TITLE: AIR CONDITIONING - AIR COOLING SYSTEM - INTRODUCE MODIFIED RAM AIR

MODIFICATION No.: 24371K3771 ATA SYSTEM: 21

Herewith Revision No. 1 of Service Bulletin A320-21-1088.

SERVICE BULLETIN No.: A320-21-1088

Component Location Figure 1, Sheet 1 of 3

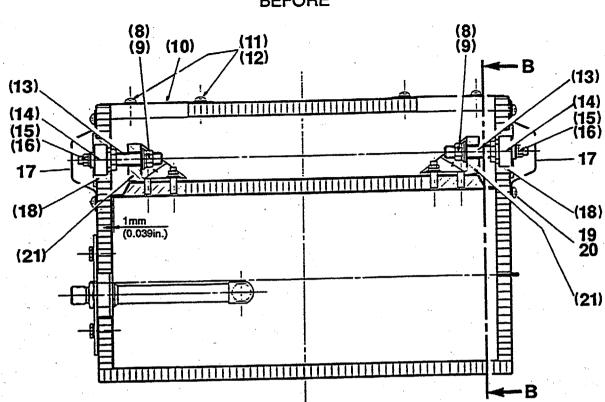
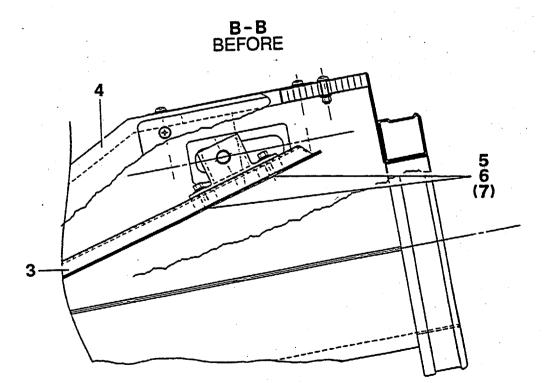
Refer to Figure 1

- (a) Remove and retain the high pressure bellows from the rear of the air inlet diffuser, item 4 (Refer to AMM 21-61-51, P. Block 401).
- (b) Remove from the ram air inlet, item 1 and item 2 these items:

screw	item 5	retain
washer	item 6	retain
nut	item (7)	discard
nut	item (8)	discard
washer	item (9)	discard
cover plate	item (10)	discard
screw	item (11)	discard
washer	item (12)	discard
bolt	item (13)	discard
bearing	item (14)	discard
nut	item (15)	discard
washer	item (16)	discard
cover	item 17	retain
guide bar bracket	item (18)	discard
screw	item 19	retain
washer	item 20	retain
ramp support	item (21)	discard

as shown in section A-A and B-B.

Modification of the Ram Air Inlet Figure 1, Sheet 2 of 3

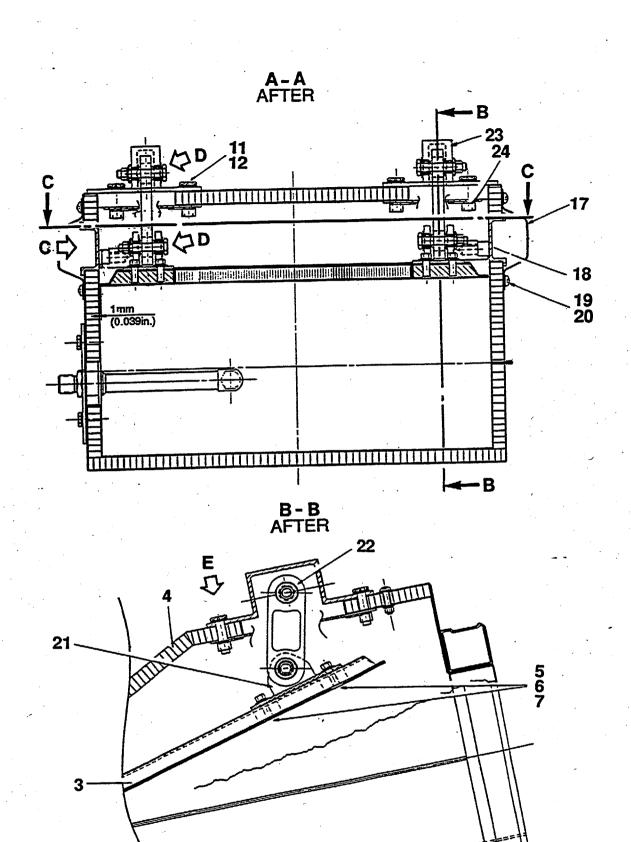
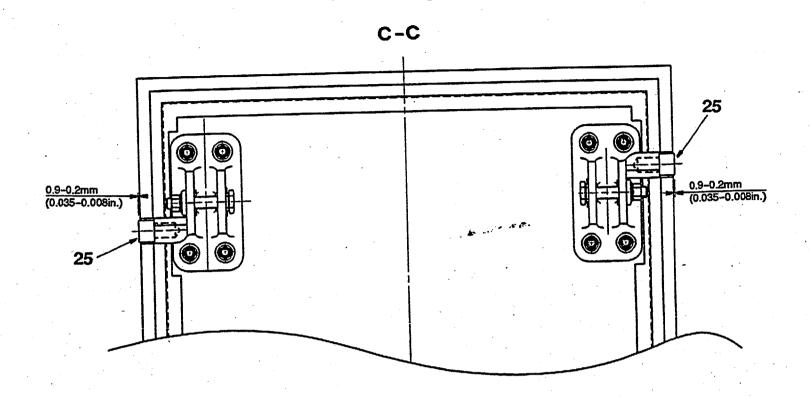
- (c) Drill through the existing inserts first with 4.0mm (0.157in.) than with 6.4mm (0.252in.)
- (d) Connect the swing lever, item 22 to the ramp support, item 21 with these items:

as shown in section B-B and detail D.

(e) Install the ramp support D2157101020600, item 21 to the diffuser ramp, item 3 with these items:

as shown in section B-B and C-C.

(f) Install the swing lever support D2157101020000, item 23 to the inlet air diffuser, item 4 with these items:

as shown in section A-A.

(g) Install the swing lever D2157113100000, item 22 to the swing lever support, item 23 with these items:

as shown in detail D.

- (h) Secure the bolts, item 11 with lockwire LN9424-1.4314.9-0.8, item 33 as shown in detail E.
- (i) Install the side guide D2157101021400, item 18 to the inlet air diffuser, item 4 with the retained washers, item 6 and screws, item 5 and bolts MS21042-3, item 26 as shown in section A-A and detail C.
- (j) Install the retained cover, item 17 with the retained washers, item 20 and screws, item 19.
- (k) Install the retained high pressure bellows to the rear of the inlet air diffuser, item 4 (Refer to AMM 21-61-51, P. Block 401).

Adjustment of the Ram Air Inlet Figure 2, Sheet 1 of 2

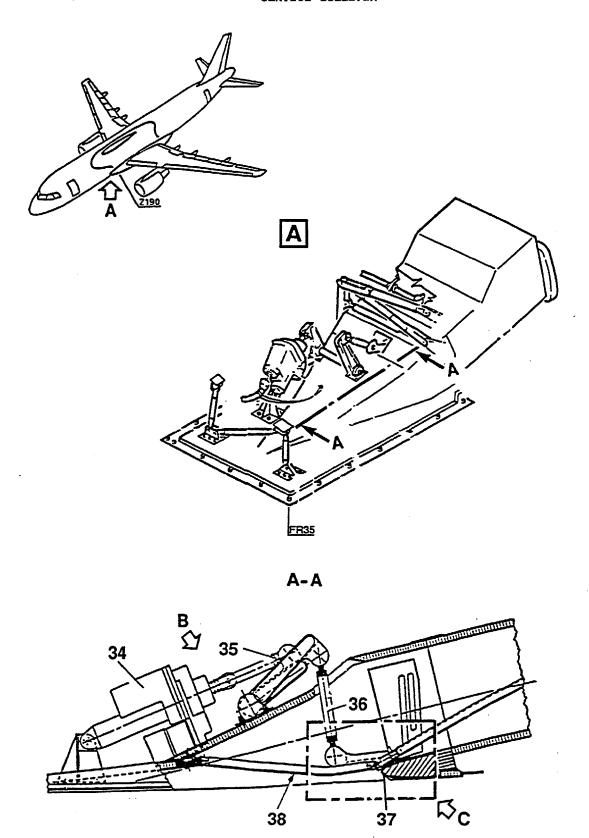
Refer to Figure 2

- (a) Set markings to the position as follows, shown in detail C.
 - 1 At the diffuser ramp, item 3:
 - distance approx. 10mm (0394in.) from the flap hinge
 - lateral distance approx. center of the intake

- distance approx. 10mm (0.394in.) from the edge of the intake nose, item 37
- lateral distance approx. center of the intake
- (b) Measure the actual rod position 'A' of the electrical actuator, item 14, shown in detail B
- (c) Transfer the measured distance 'A' to the graph and determine the flap position 'B' (inlet gap) with the graph.
- (d) Measure the gap between the marked positions at the intake nose, item 37 and the diffuser ramp, item 3.
- (8) Compare the determined inlet gap 'B' with the actual diffuser ramp position 'B', shown in detail C
 - If the actual diffuser ramp position (inlet gap) is in the determined position 'B', proceed with Para. 2.B.(10).
 - If the actual diffuser ramp position (inlet gap) is not in the determined position 'B', proceed with Para. 2.B.(9).

NOTE: The tolerance of the compared diffuser ramp position is +1.5mm (0.059in.).

- (9) Adjustment of the gap between intake nose and diffuser ramp
 - (a) Disconnect the mechanism at the rod of the electrical actuator, item 34 in accordance with the AMM 21-61-51, P. Block 401.

- (b) Adjust flap position by rotating the rod end half a turn (half turn corresponds to 0.5mm (0.019in.) movement.
- (c) After the adjustment, connect the mechanism in accordance with the AMM 21-61-51, P. Block 401 and torque tighten the lock nut to 0.6 daNm (53.09 lb.in.) and secure with the tap washer.
- (10) Make sure that the work area is clean and clear of tools and other items.

Adjustment of the Ram Air Inlet Figure 2, Sheet 2 of 2

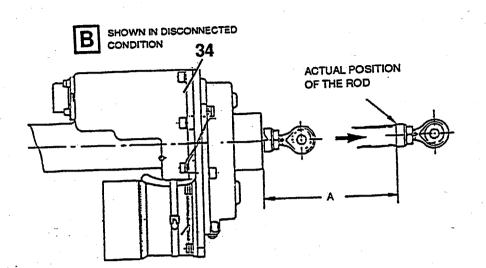
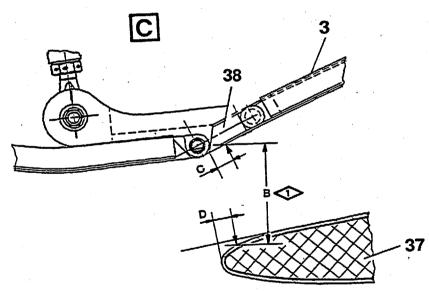
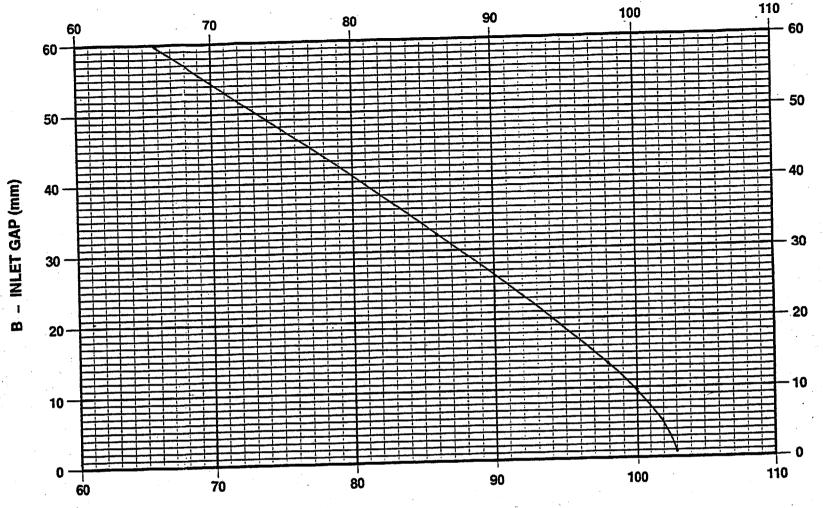
A = TO BE MEASURED! B = TO BE DETERMINED WITH THE GRAPH (SEE RH SIDE)

TOLERANCE +1.5 mm (0.059 in.)
C = 10 mm (0.394 in.) TO FLAP HINGE
D = 10 mm (0.394 in.) FROM EDGE

LATERAL POSITION IS APPROX. CENTER OF THE INTAKE
